Licensee: St. Peter's University Hospital
License No.: 29-07566-01
Docket No.: 03002502
Control No.: 140559

July 16, 2007

This is in response to your email requesting additional information regarding our amendment application for the use of GliaSite RTS.

RADIATION ONCOLOGY
TREATMENT ROOMS FOR
ADMINISTRATION

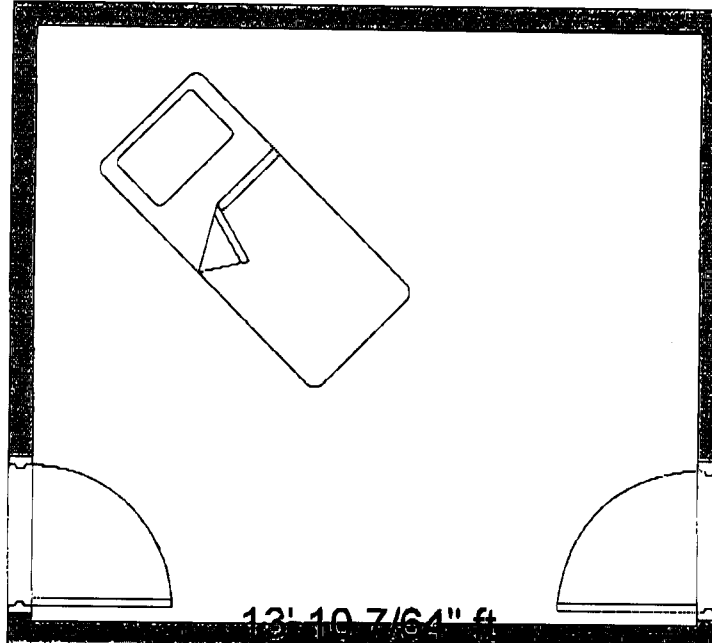
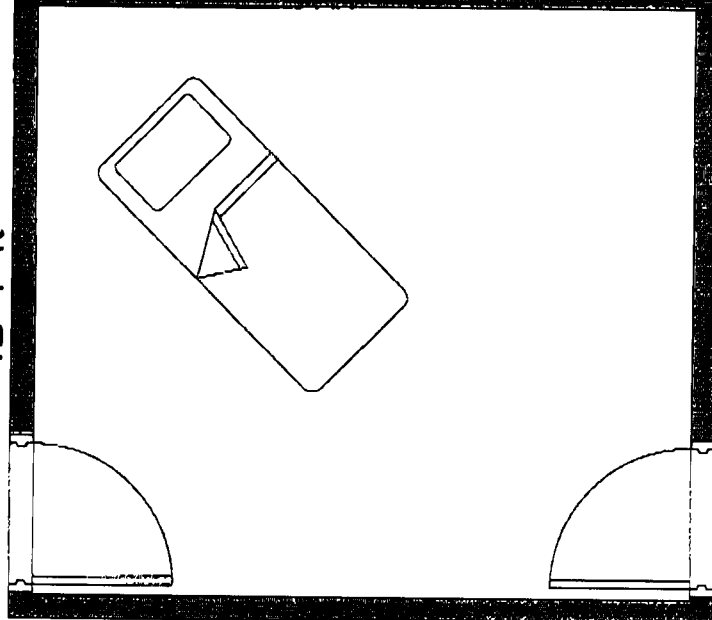
4. Provide the locations where the Iotrex will be prepared and administered. If patients are unable to be released from the hospital, identify the inpatient room(s) where the patients will be housed and confirm that these are private rooms with private baths. If you have not already provided to the NRC room diagrams of the locations where Iotrex will be prepared, administered, and inpatient rooms, please submit these.

The Iotrex will be prepared in the Nuclear Medicine Hot Lab and administered in one of the Radiation Oncology treatment rooms (see Attachment 1).
